**Regulatory Oversight Report for
Canadian Nuclear Laboratories
Sites: 2021**

Technical Review of the Regulatory Oversight Reports for Canadian Nuclear Laboratories (CNL) Sites: 2021

Manitoba Métis Federation

September 27, 2022

Figure 4. Total loadings for the Direct Discharge of Radionuclides at the Whiteshell Laboratories facility.¹

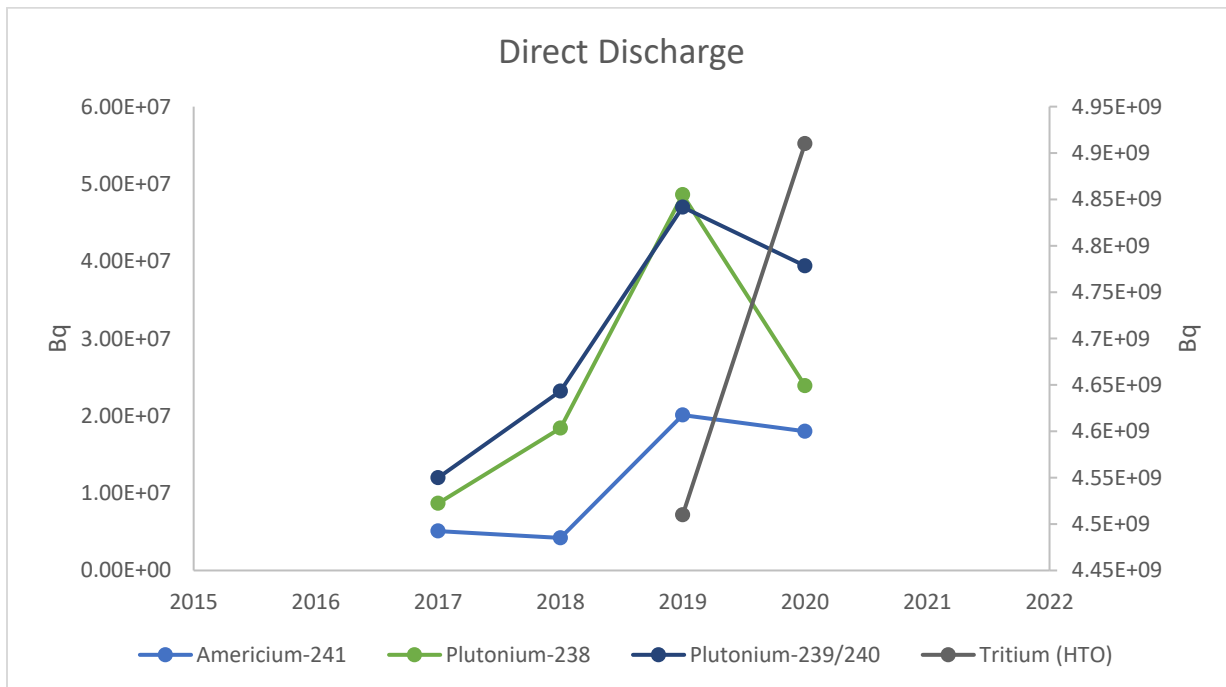
As noted in the MMF's previous submissions, we are surprised that plutonium is being released to the environment from the WL facility, given that it is a nuclear fission product. At WL, the receiving environment is the Winnipeg River which flows to Lake Winnipeg. Although the amounts are well below the Derived Release Limits, it is unclear where these particular radionuclides, especially plutonium, are coming from in the wastewater measurements. As a result, these releases are of significant concern to Métis citizens that fish in the river and fish, some commercially, in Lake Winnipeg. The CNSC should discuss the source of these nuclides on the WL site and if it is possible to remove the source or contain the nuclides by isolating the source. Without these controls, these releases will extend well into the future for uranium, plutonium, and americium isotopes. Further, the MMF raises concerns that direct discharge information on radionuclide loadings is unavailable for 2021. Loadings specifically for americium, plutonium, tritium, and particulate gross beta were observed to be elevated in 2019 and 2020 compared to observed minimums in 2017 and 2018 (Figure 5). The MMF is concerned that these radionuclides were not assessed in 2021. If this indeed is the case, the MMF request additional information on the rationale for reducing sampling while these values appear to be increasing.

- Discuss with the MMF the source(s) of downstream radionuclides from the WL site, as well as options for improved source control and monitoring.
- Update the Whiteshell Laboratories Comprehensive Study Report to include the impacts of decommissioning, particularly in light of the possible in situ entombment of the WR-1 reactor. The focus of the update needs to be on remaining hazards and the potential dose to the public and potential future users of the land.
